Technical Service Bulletin: TSB140133

New Rear Gear Camshaft Idler Shaft

This document introduces a replacement rear gear camshaft idler shaft and associated parts.

Figure 1, Obsolete Design

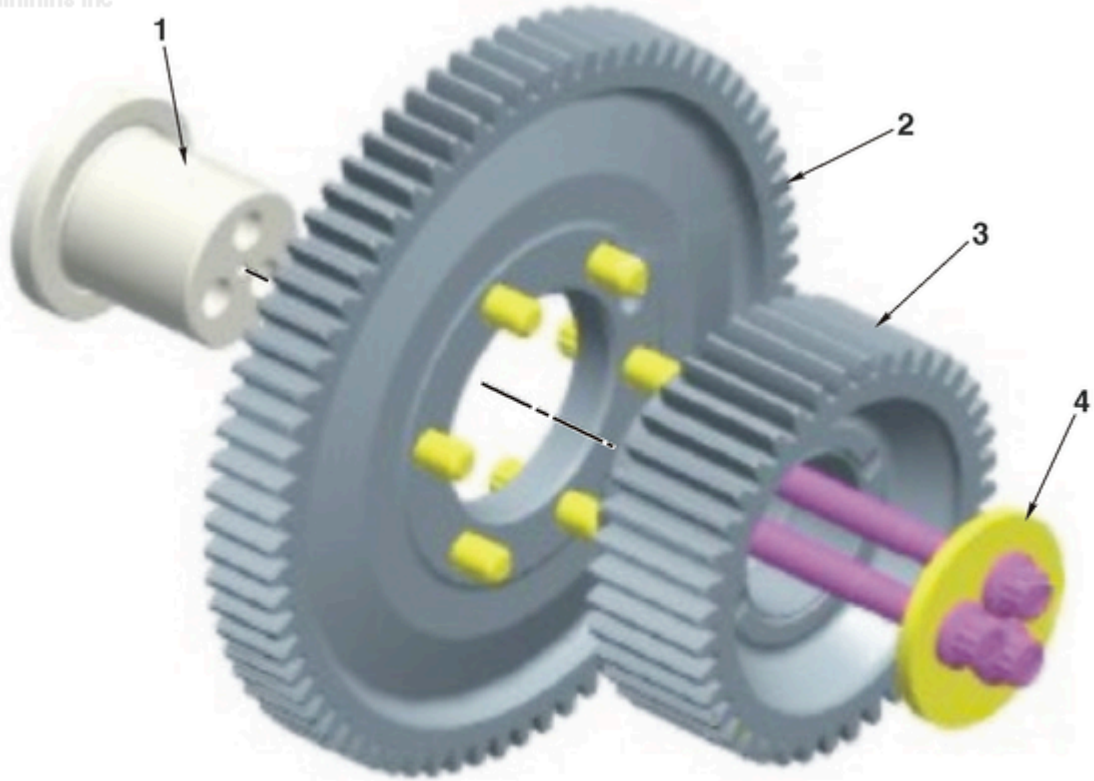
Replacement idler gear with bushing and idler gear retainer released with replacement rear gear camshaft idler shaft. See Figure 1 and 2.

New design includes improved clamp load for rear gear camshaft idler shaft and improved idler gear bushing lubrication.

Obsolete rear gear camshaft idler shaft and idler gear with bushing not compatible with replacement parts. Component oil lubrication will be affected, engine damage will result.

Camshaft idler shaft, idler gear with bushing, and gear retainer part numbers have been obsoleted. When replacing any of these parts, all must be replaced.
